Groundwater Transfer Review Summary Form

Transfer/PA # T- 14442

Ground Water Review Form:

Application: T-14442

Well Location Map

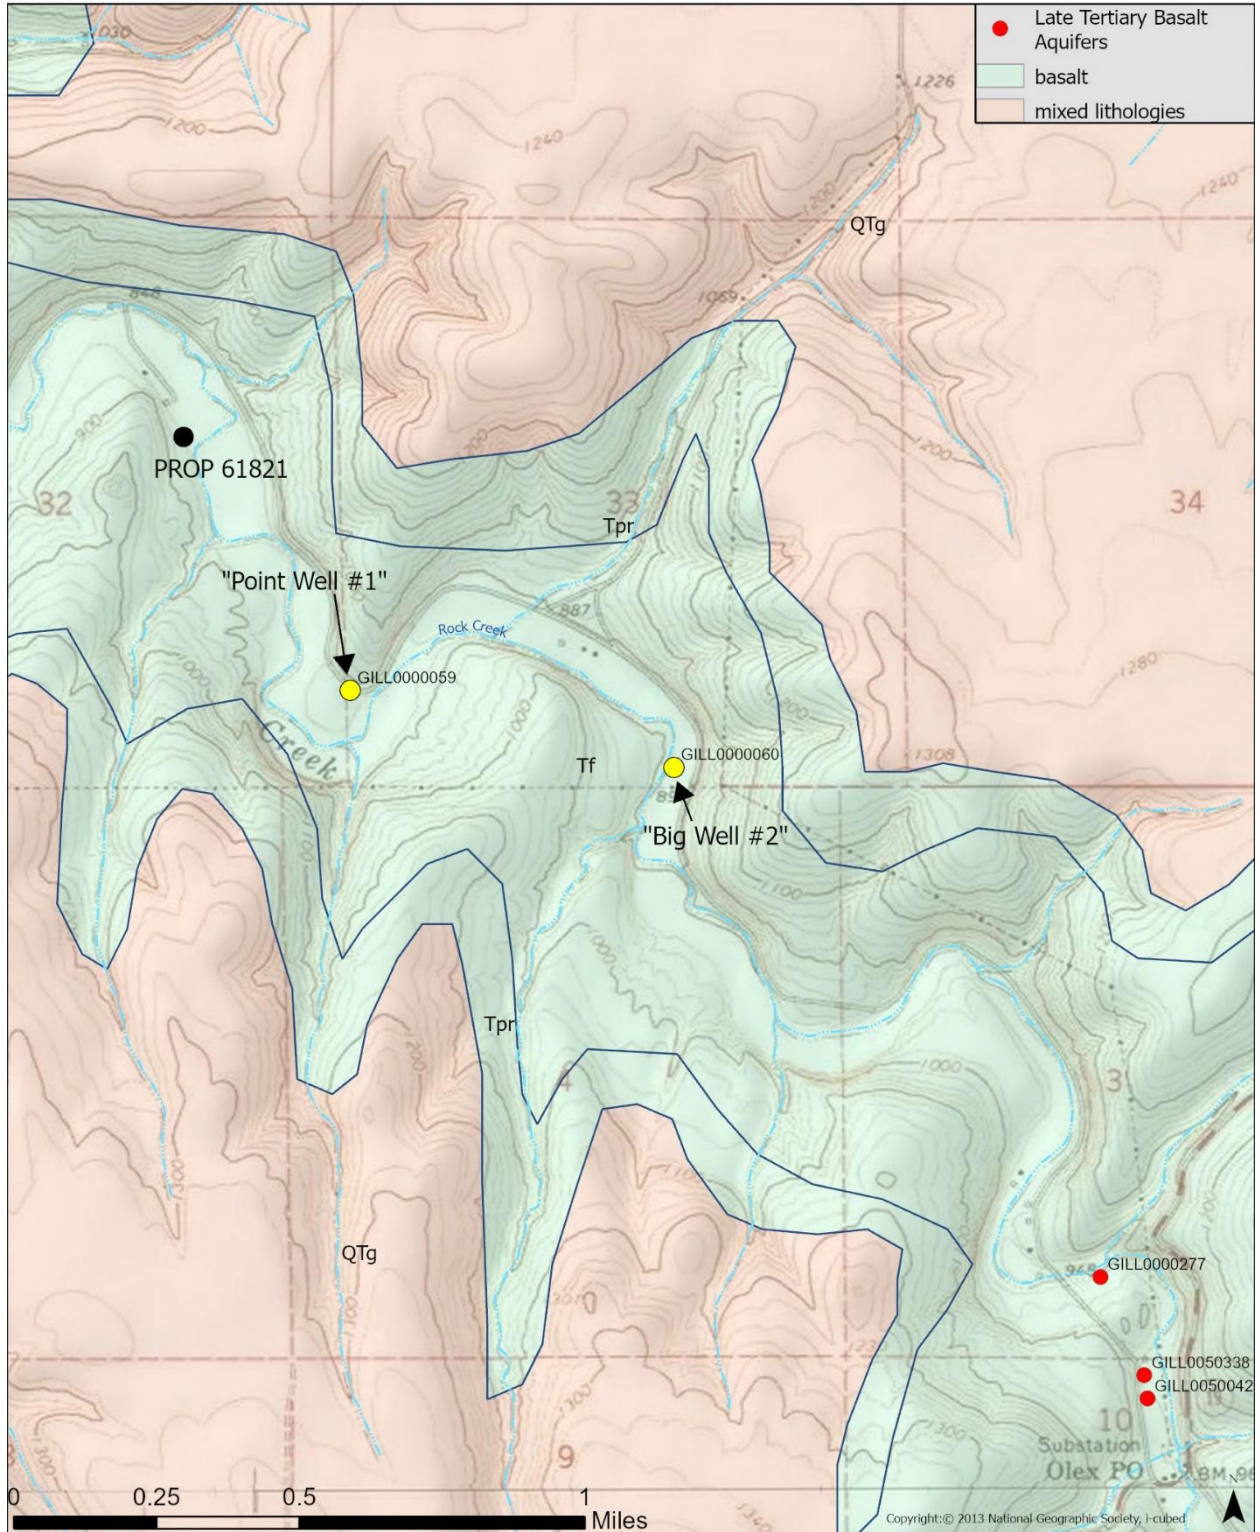
5. a) Will this proposed change, at its maximum allowed rate of use, likely result in an increase in interference with **another ground water right**?
 Yes No Comments: The groundwater rights nearest to the POAs are associated with GILL 277 and PROP 61821. PROP 61821 has not been drilled as of 2/19/2025, but has a proposed completion depth of 600 feet, similar to the POAs. The estimated increase in interference at GILL 277 based on pumping at the maximum combined rate at GILL 60 vs pumping at the current maximum authorized rate at both wells is approximately 1 foot. Similar modeling for pumping at the maximum combined rate at GILL 59 results in an increase of between 1 and 5 feet of interference at the proposed site for PROP 61821.

Drawdown at GILL 277 pumping at the current authorized rate at GILL 59

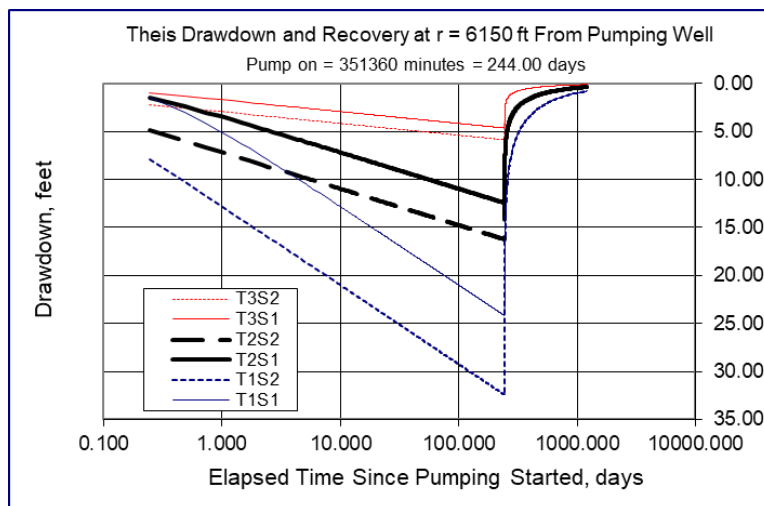
- b) If yes, would this proposed change, at its maximum allowed rate of use, likely result in another groundwater right not receiving the water to which it is legally entitled?
 Yes No If yes, explain: The resulting increase in interference at GILL 277 when pumping at the maximum allowable rate is negligible. The resulting increase in interference at PROP 61821 is greater, but not enough to dewater the well if pumping at the maximum allowed rate of 1.84 cfs (Permit G17332) over the course of the irrigation season.
